# Intel® 80331 I/O Processor

## Specification Update

| *April 2006*

Order Number: 273930-021US

**Table 236. DDR SDRAM Control Register 0 - SDCR0 (Sheet 2 of 2)**

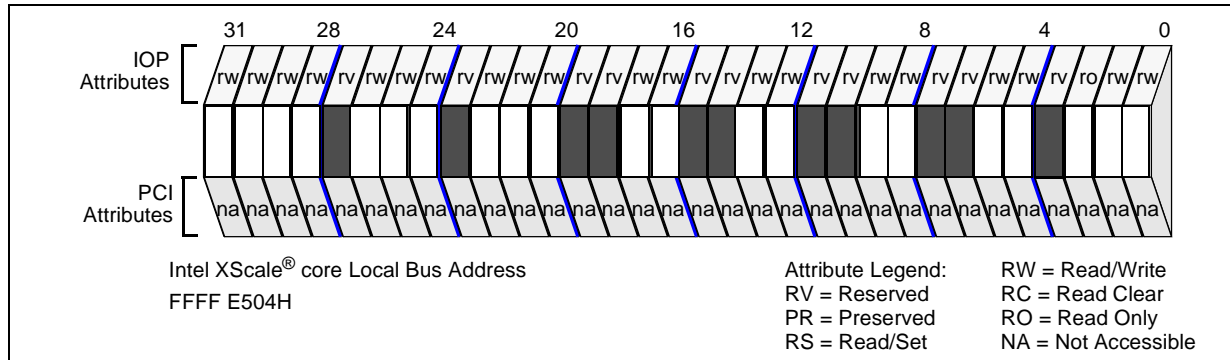
**Table 236. DDR SDRAM Control Register 0 - SDCR0 (Sheet 1 of 2)**

Bit	Default	Description
07:06	00 <sub>2</sub>	Reserved.
05:04	00 <sub>2</sub>	ODT Termination Value: Determines the termination value of the On Die Termination for both Banks (controlled by <b>ODT[1:0]</b> ). Applies to DDR-II SDRAM memory type only. <ul style="list-style-type: none"> <li>00 Disabled</li> <li>01 75 ohm</li> <li>10 150 ohm</li> <li>11 reserved</li> </ul>
03	0 <sub>2</sub>	Reserved
02	Varies with external state of <b>MEM_TYPE</b> at PCI bus reset	<b>DDR Type:</b> Identifies the selected DDR generation of SDRAM based on the <b>MEM_TYPE</b> reset strap. 0 = DDR-II (supported speed of 400 MHz) - <b>MEM_TYPE</b> Deasserted. 1 = DDR (supported speed of 333 MHz) - <b>MEM_TYPE</b> Asserted.
01	0 <sub>2</sub>	<b>Data Bus Width:</b> Indicates the width of the data bus. See <a href="#">Section 8.3.3.4, “32-bit Data Bus Width” on page 458</a> . 0 = 64 bits 1 = 32 bits
00	0 <sub>2</sub>	<b>DIMM Type:</b> Selects unbuffered or registered DIMM operating modes for the MCU. 0 = Unbuffered* 1 = Registered <b>NOTE:</b> Unbuffered DDR SDRAM memory subsystems will use the Unbuffered mode.
